**Re: Planning Proposal – Patyegarang (formerly Lizard Rock)**

**RE: PLANNING PROPOSAL – PATYEGARANG, MORGAN ROAD, BELROSE**

### **Patyegarang Planning Proposal (PP-2022-3802)**

**Subject: Consultation and exhibition - Planning Proposal Patyegarang (PP-2022-3802)**

Figure 2 – Wastewater Location Map

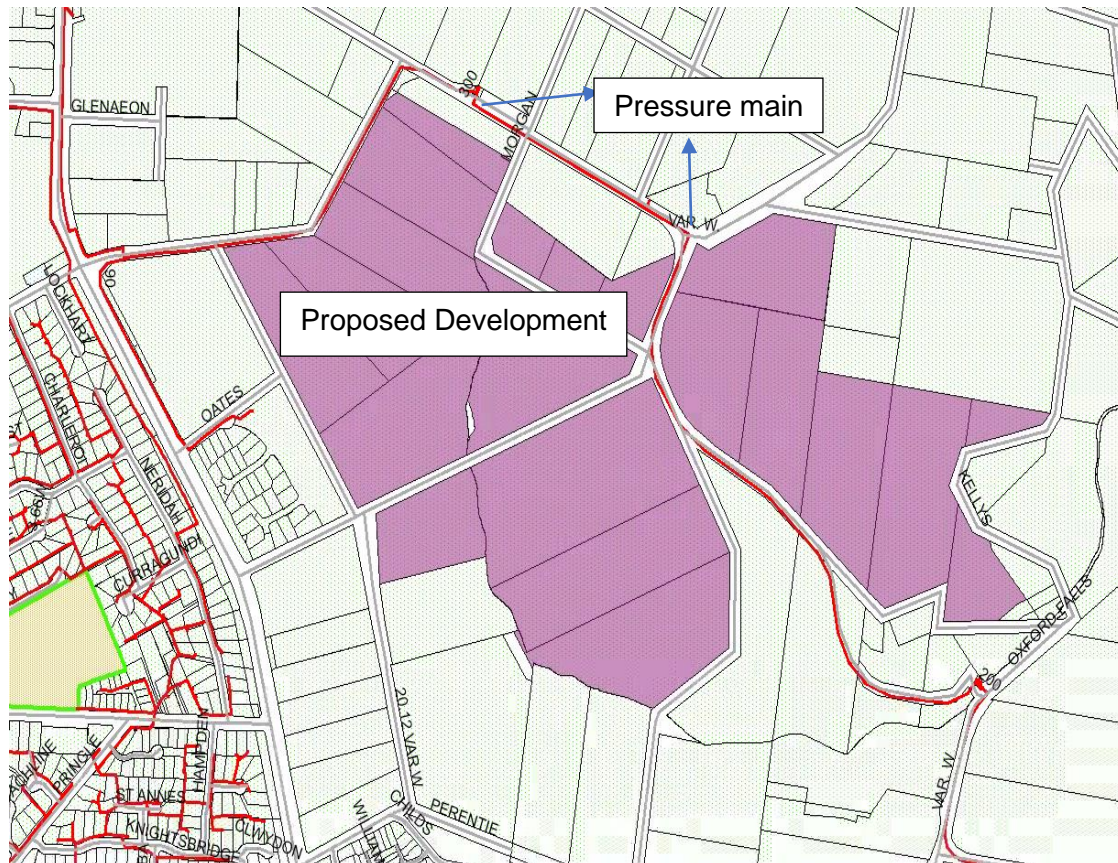
- The proposed development lies outside the Sydney water Warriewood and West Middle Harbour wastewater servicing catchments. This proposed development is not included in

the Warriewood 2021 GSIP study or any other growth planning studies. The high level assessment indicates that Warriewood network has some capacity constraints. However, treatment plant has capacity to service the proposed 450 dwellings. Therefore, to service the development, developer needs to engage a consultants to investigate the network capacity, connection point and any network upgrade requirements if required.

Figure 1 – Crown Roads

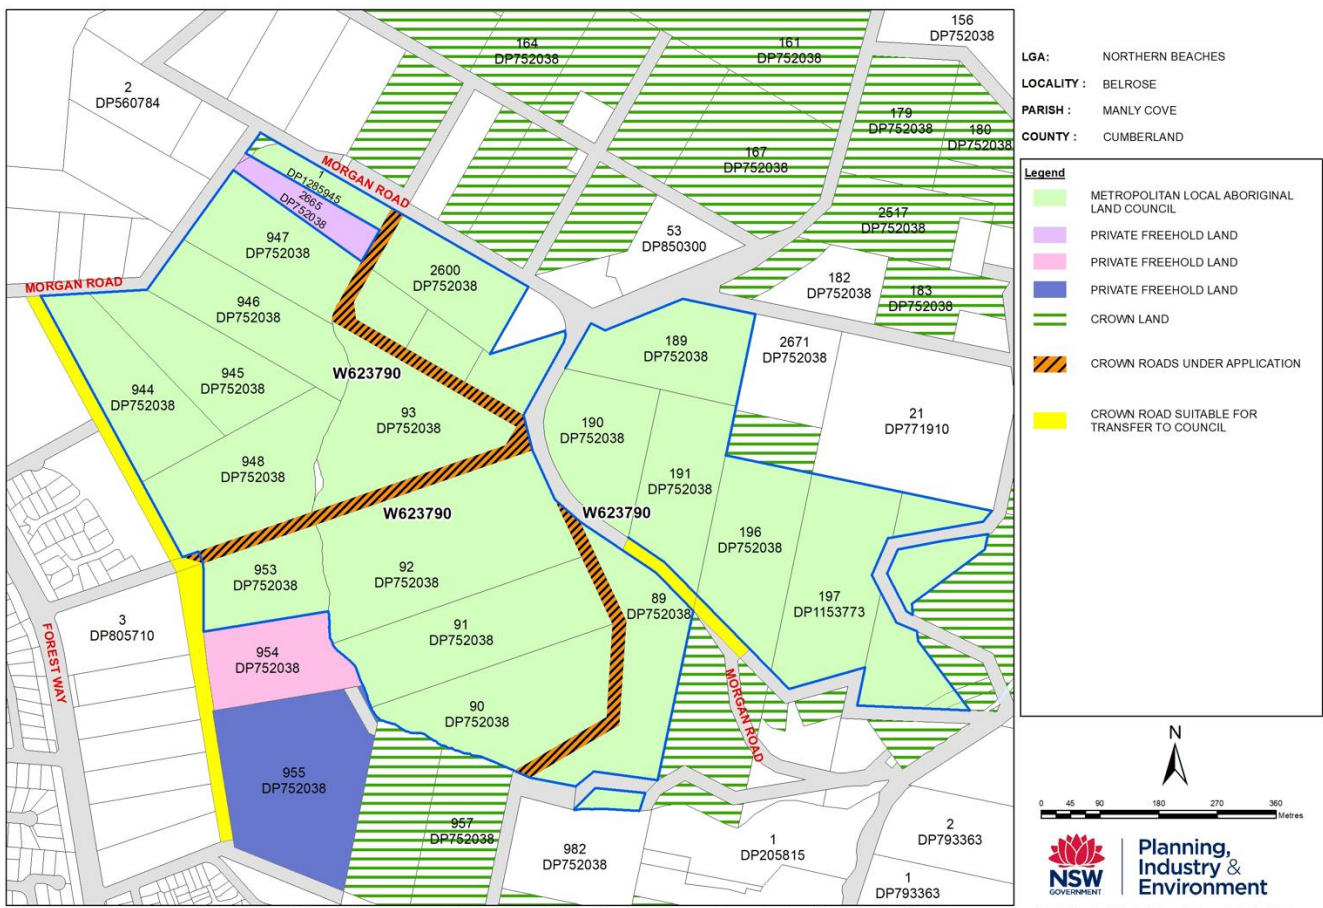
Please refer to Figure 1 below depicting the Crown roads within or adjoining the proposal area. The Department has received applications to close and purchase all the Crown roads within the proposal area, identified in orange with cross hatching 'CROWN ROADS UNDER APPLICATION'. The Crown roads suitable for transfer to Northern Beaches Council (Council) are identified in yellow 'CROWN ROADS SUITABLE FOR TRANSFER TO COUNCIL'.

There is also a small section of Morgan Road (a Council public road) adjoining Lots 191 and 196 in DP752038 on the south-eastern side of the proposal area, that is still a Crown road as depicted in Figure 1 and Figure 4 below. This part of Morgan Road, which is constructed and provides access to numerous developments, meets the criteria for transfer to Council.

Figure 5 – Crown Reserve R83616

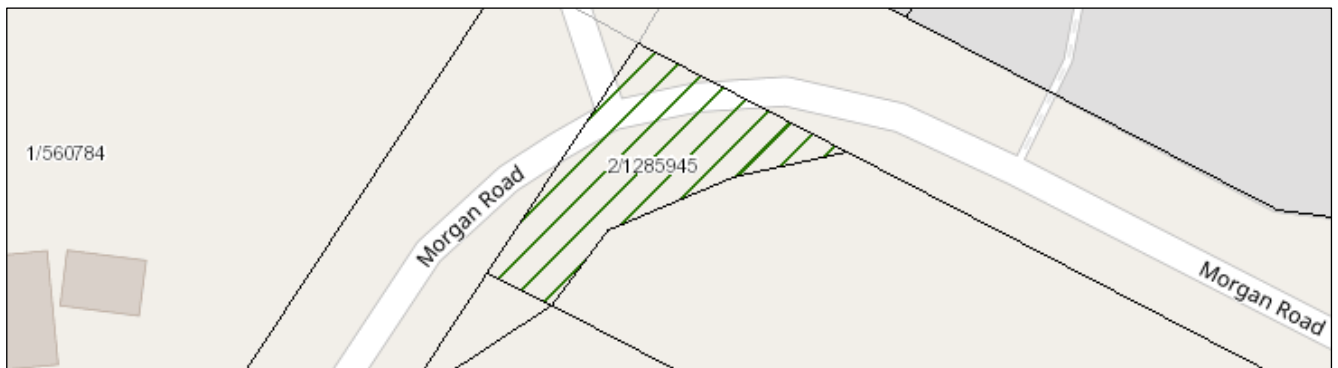
There is also a small parcel of Crown Reserve known as R83616 (Figure 5) that has been included in the proposal area (Figure 2) as Retained Vegetation & Open space/Protected Area. This Reserve is 633.2m<sup>2</sup> in size, being Part Lot 2, DP1285945. This is a Crown Reserve and therefore cannot form part of the proposal area.
